APPEAL SUMMARY

Appeal ID: 20240

Project Address: 3450 N Williams Ave

Building/Business Name: Canyons

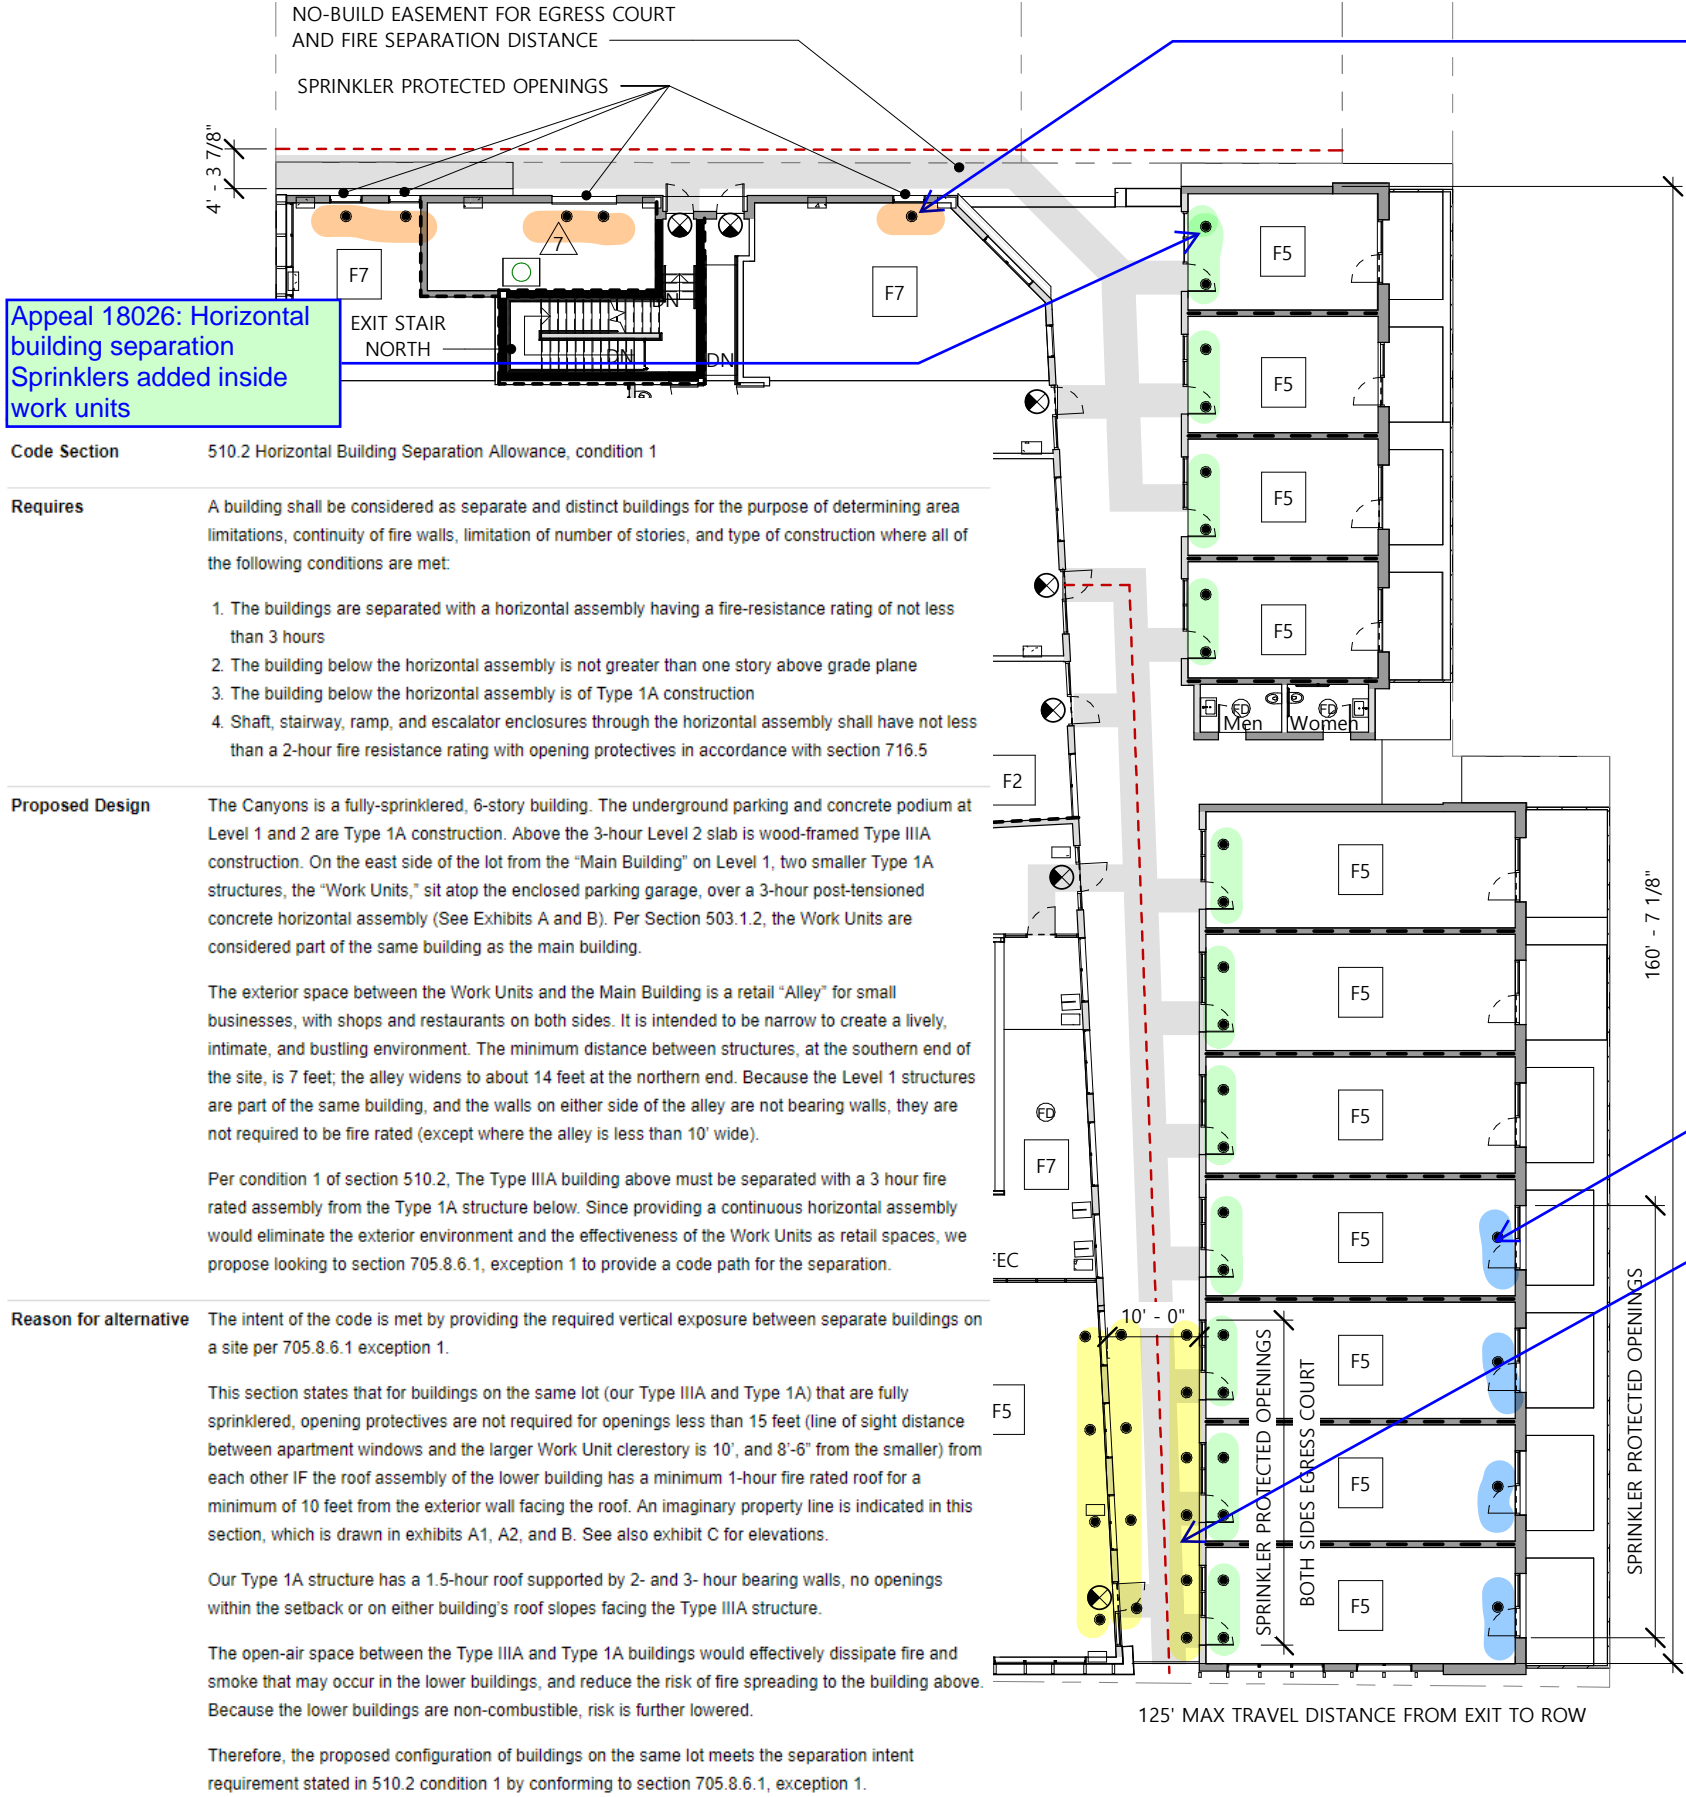
Proposed Design Reconsideration Text: In appeal 18495 Item 2, we proposed sprinkler heads on both sides of the exterior walls where the egress court is less than 10 feet wide. In reviewing the design against other code appeals on the same project, we revise this suggestion to propose fire sprinklers on the occupied side of the exterior wall only. The approach satisfies the intent of the code for this fully sprinklered building, as per appeal #18032 Item 3 for egress courts. See attachment for a diagram of all fire-sprinkler related appeals for the project.

Reason for alternative Reconsideration Text: Fire sprinklers on the occupied side of openings provides equivalent for the ¾ hour protectives required in the code for egress courts. Therefore, the sprinkler heads on the exterior side of the openings are not required.

Appeal 18026: Horizontal building separation
Sprinklers added inside work units

Appeal 18032 Item 3: Fire curtain in lieu of fire rated openings - occupied side of openings

Appeal 18495 Item 3: Buildings on separate lots

Appeal 18495 Item 2: Non-fire rated openings replaced with sprinklers both sides of openings

Type 13 water curtain sprinkler protection on interior side of non-fire rated openings in exterior walls of egress court less than 10' in width: Granted provided there are no projections or awnings in the appealed area and provided windows are non-operable, doors are on a closer and sprinklers are spaced not more than 6 feet apart and placed a minimum of 6 inches and a maximum of 12 inches from the opening(s) and a maximum of 12 inches below the ceiling. Sprinklers are to be installed on the occupied sides of the openings. A separate permit from the Fire Marshal's Office is required. Appellant may contact John Butler (503 823-7339) with questions.

Vertical separation of 1-A from III-A construction: Granted provided townhouse openings along the courtyard have sprinklers spaced not more than 6 feet apart and placed a minimum of 6 inches and a maximum of 12 inches from the openings and a maximum of 12 inches below the ceiling and the wall along the courtyard is rated a minimum of 1 hour. No openings are allowed on the west roof of the townhouse building.

3. Type 13 water curtain sprinkler protection at non-fire rated wall openings of exterior egress balcony where separation from interior of building is required: Granted provided windows are non-operable and sprinklers are spaced not more than 6 feet apart and placed a minimum of 6 inches and a maximum of 12 inches from the opening(s) and a maximum of 12 inches below the ceiling. Sprinklers are to be installed on the occupied side of the openings. A separate permit from the Fire Marshal's Office is required.

2. Type 13 water curtain sprinkler protection at non-fire rated openings in exterior walls of egress court less than 10' in width: Granted provided windows are non-operable, doors are on a closer and sprinklers are spaced not more than 6 feet apart and placed a minimum of 6 inches and a maximum of 12 inches from the opening(s) and a maximum of 12 inches below the ceiling. Sprinklers are to be installed on the occupied and exterior sides of the openings. A separate permit from the Fire Marshal's Office is required.
